IN THE DRAWINGS

REMARKS

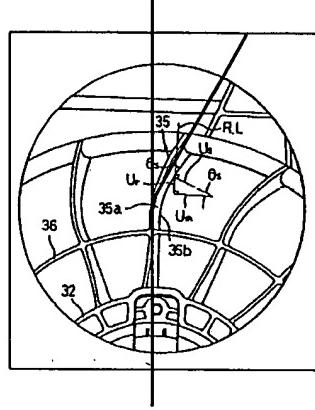
The Examiner points out that the angle of projection is increased when it gradually approaches the tip in Fig. 8 of Cho. In addition, the Examiner also points out that an r/R value of the second outlet area is about 0.57 when it is measured in the drawing and an air flow guide surface is curved into the form of an arc between a leading edge and a trailing edge.

Cho limits an angle of incidence of a guide blade but does not disclose that an angle of projection of the guide blade gradually increases. Referring to FIG. 5, it can be seen that the angle of projection which is an angle formed between a tangent line at the trailing edge (35C) and a line parallel with an axis is 0° in all areas.

It is respectfully submitted that the Examiner measured the angle of an area where the guide blade is curved from a line passing the center of the fan to the right side, and so, the Examiner misconceived the angle of projection as a value to indicate the curved level.

It is respectfully submitted that the angle of projection gradually increases from 0° to 30° since the Examiner measured an angle formed between the two straight lines as shown in the drawing below:

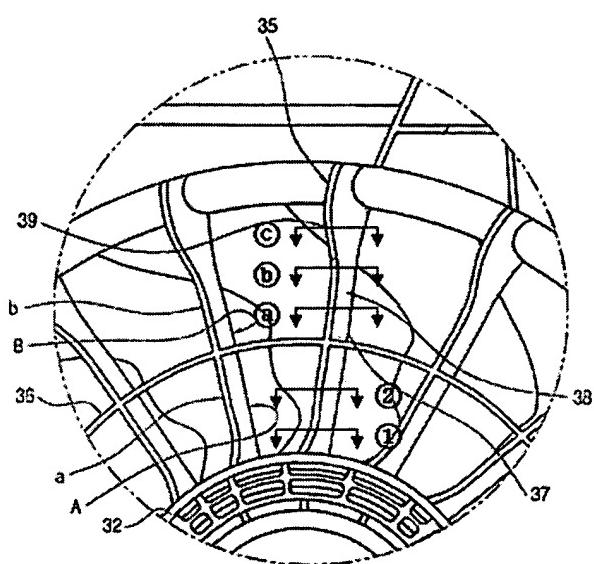
The Examiner points out that an r/R value ranges from 0.4 to 0.7 and an air flow guide surface is curved into the form of an arc from a leading edge to a trailing edge.

According to Tsubakida, the outlet area referred to by the Examiner means an area that a guide blade is curved at a predetermined angle to a part parallel with a line passing the center of the fan.

However, according to the presently claimed invention, the first outlet area is an area that the angle of projection is 0° but the second outlet area is an area that the angle of projection gradually increases.

<First outlet area>

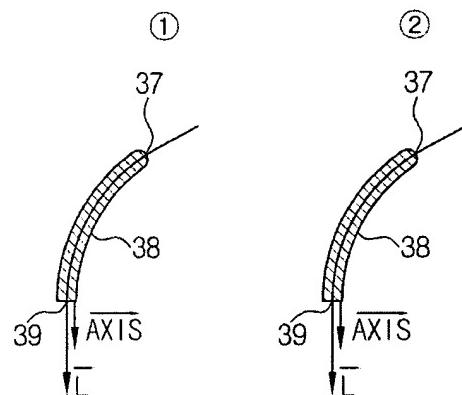
To aid the Examiner, Fig. 5 of this application, is described in more detail below. When a tangent vector at the trailing edge is L vector and a vector parallel with an axial direction is an AXIS vector, the angle of projection is 0° in all areas of the first outlet area (a) since directions of L vector and AXIS vector coincide, but an angle formed between the L vector and the AXIS vector gradually increases in the second outlet area (b) as becoming more distant from the center of the fan.
